PLANNING COMMISSION MEETING AGENDA REGULAR MEETING

- TO: Planning Commission
- FROM: R. Brent Savidant, Community Development Director
- SUBJECT: <u>PRELIMINARY SITE PLAN REVIEW (SP JPLN2022-0008)</u> Proposed The Westington II, South of Wattles, East of Crooks (870 Barilane Drive; PIN 88-20-21-101-009), Section 21, Currently Zoned NN (Neighborhood Node "I") District

Preliminary Site Plan Review For City of Troy, Michigan

Applicant:	DesignHaus
Project Name:	The Westington Phase 2
Plan Date:	February 17, 2022
Location:	Wattles Rd, just east of Crooks Rd
Zoning:	Neighborhood Node (NN) – I
Action Requested:	Site Plan Approval

Woodlands:A tree inventory and replacement plan has been provided on Sheet L100,
with replacement trees shown in the landscape plan on Sheet L101.

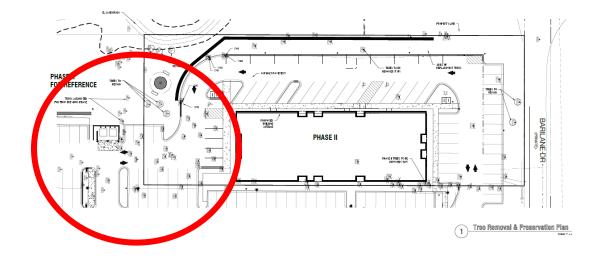
The applicant indicates that they are preserving 130 inches of trees, however, 79 of those inches are prohibited species which do not receive credit for preservation. As such the applicant has not provided the required replacement.

The applicant is preserving six (6) protected trees. We note that there is a clumping of protected trees (white pines, highlighted in red circle). Is the applicant able to shift the building or reconfigure the drive aisle to preserve additional trees?

Items to be addressed: Can the applicant shift the building or reconfigure the drive aisle to preserve additional trees?

A landscaping plan has been provided on Sheet L101. The following table discusses the development's compliance with the landscape requirements set forth in Section 13.02.

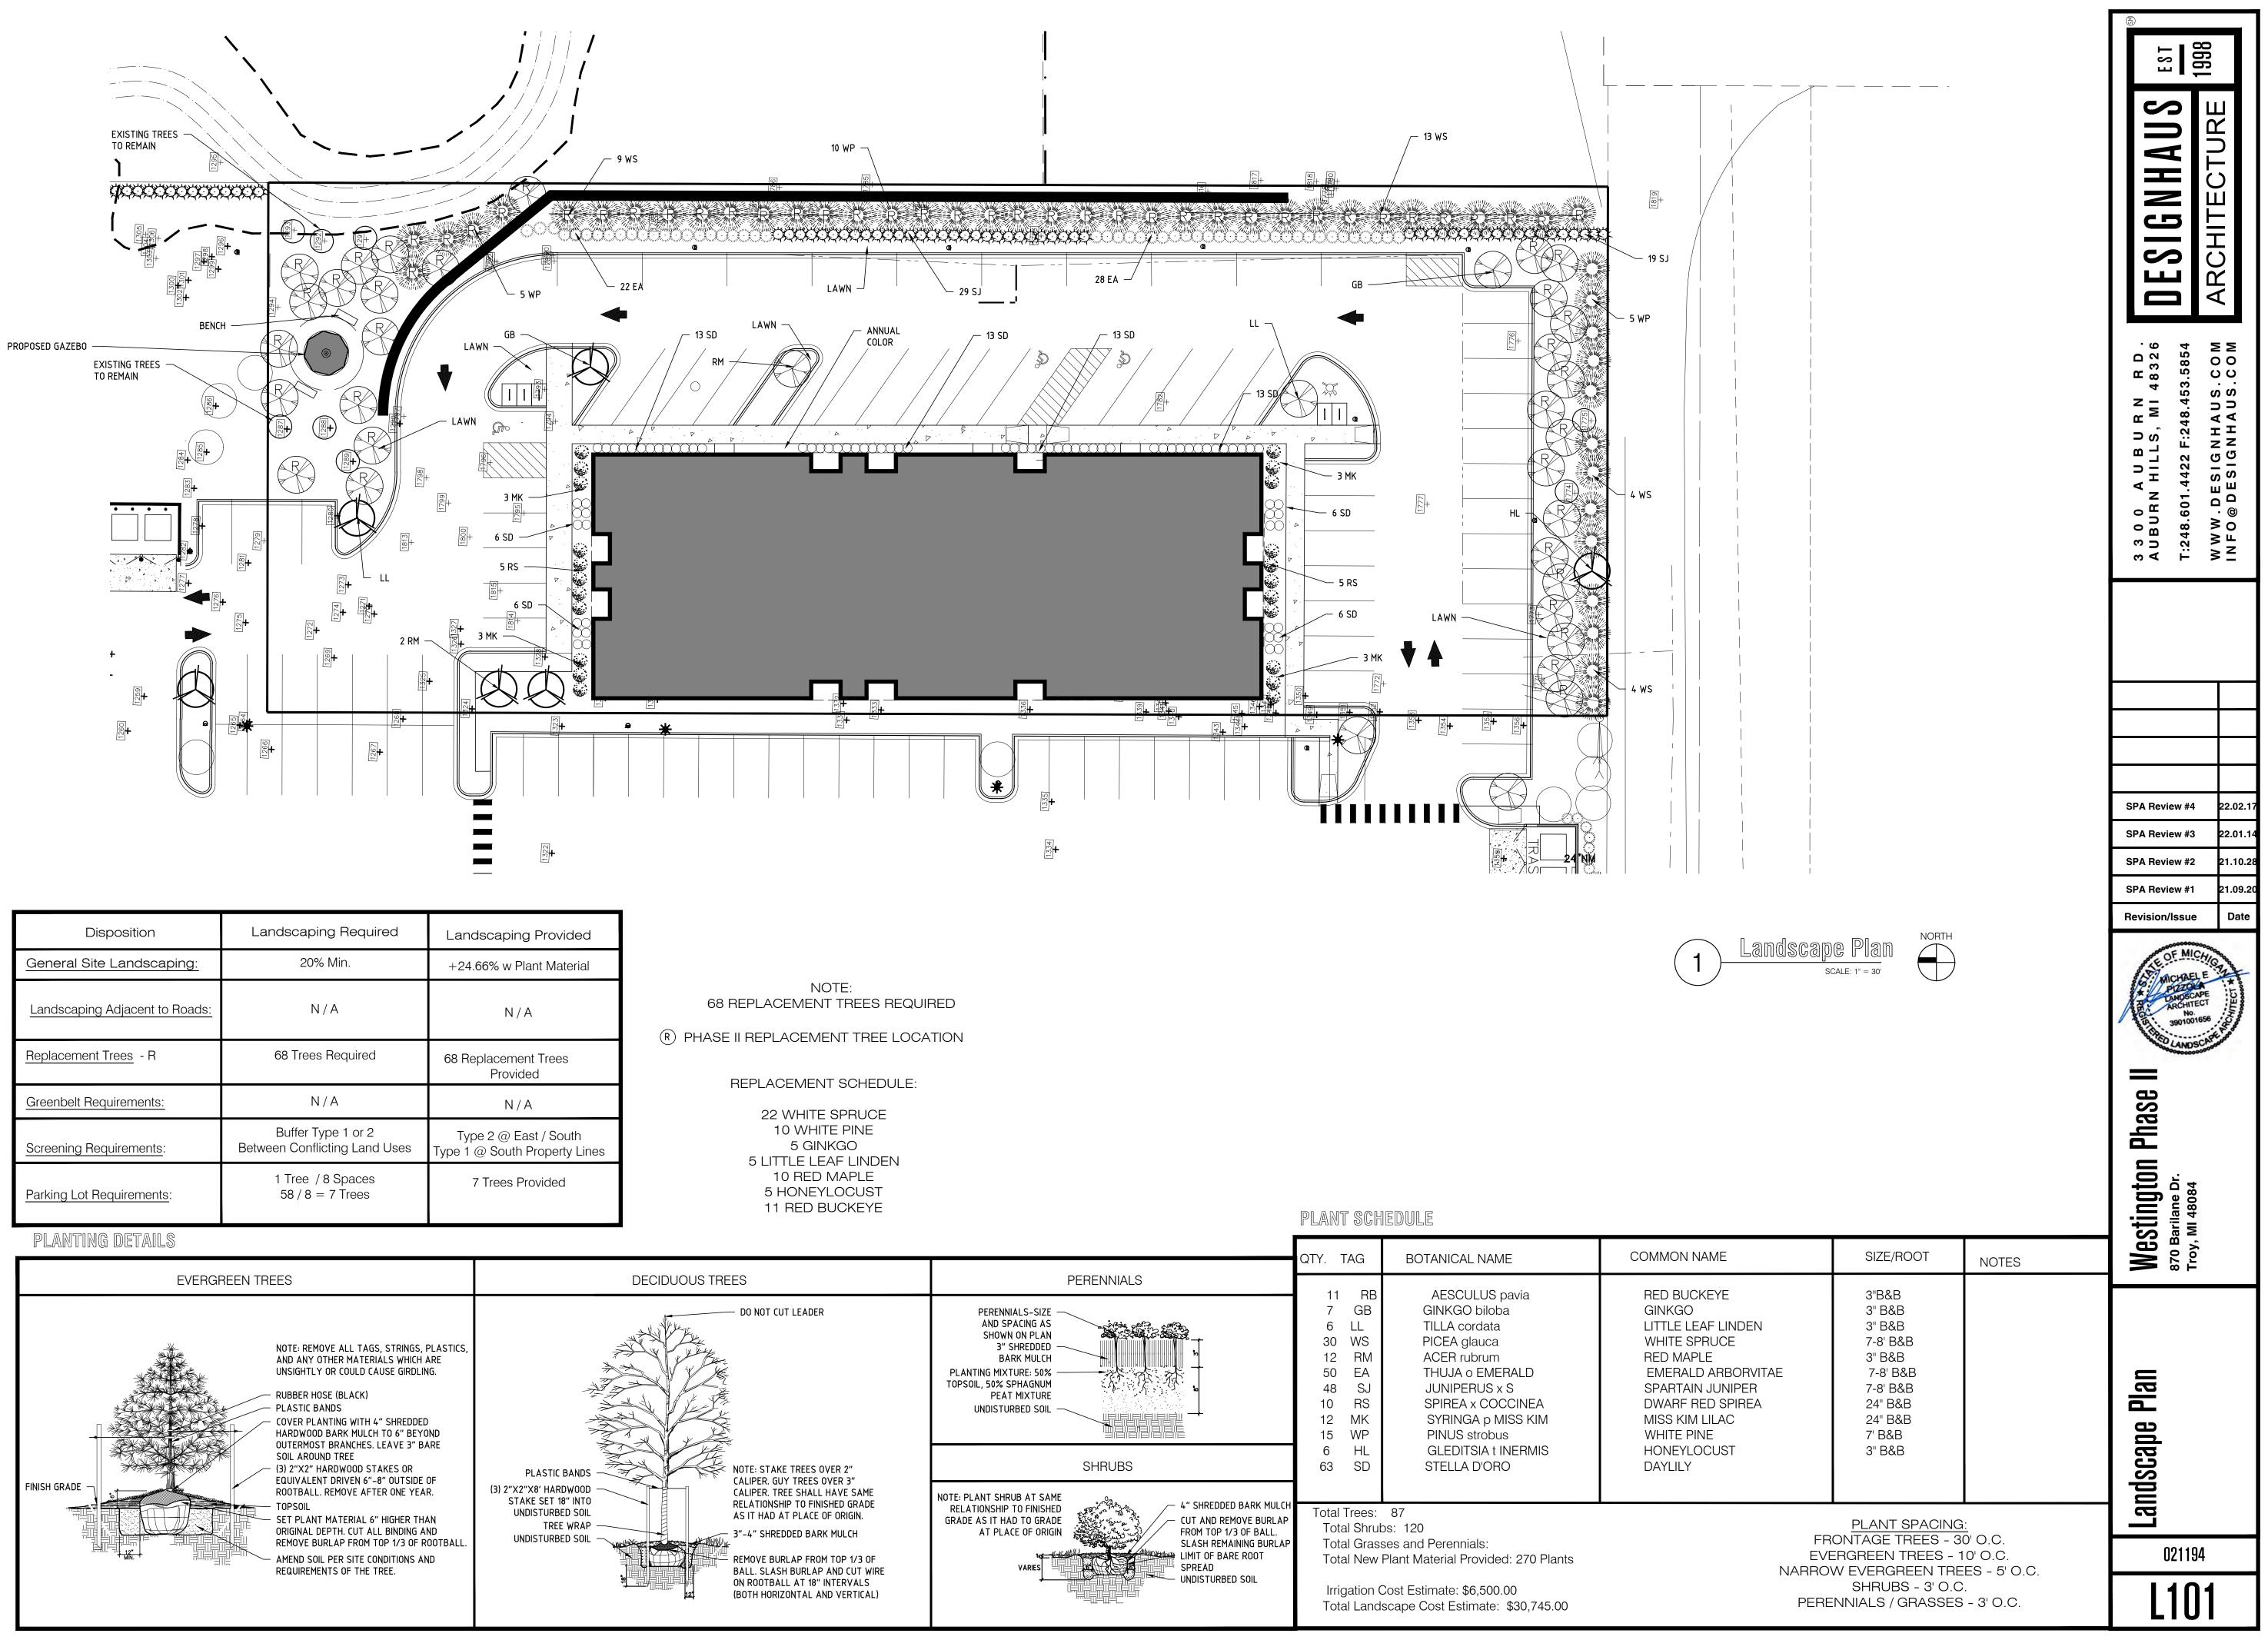
Required:	Provided:	Compliance:
East Property Line:			
Landscape buffering: Required buffering between two differentiating land uses. Alternative 1 or 2.	 1 large evergreen every 10 feet or 1 narrow evergreen every 3 feet. Alternative screening method may be considered by the Planning Commission. 	1 narrow evergreen every 3 feet.	Complies
Southeast property line: (adjacent to existing single- family home)			
Landscape buffering: Required buffering between two differentiating land uses. Alternative 1 or 2.	 1 large evergreen every 10 feet or 1 narrow evergreen every 3 feet. Alternative screening method may be considered by the Planning Commission. 	1 narrow evergreen every 3 feet along northern property line.	Complies
West Property Line:			
Landscape buffering: None required	None required	A variety of trees and bushes, numbering approx. 164 plants.	Complies
South Property Line			
Required buffering between two differentiating land uses. Alternative 1 or 2.	1 large evergreen tree every 10 feet	12 evergreen trees	Complies
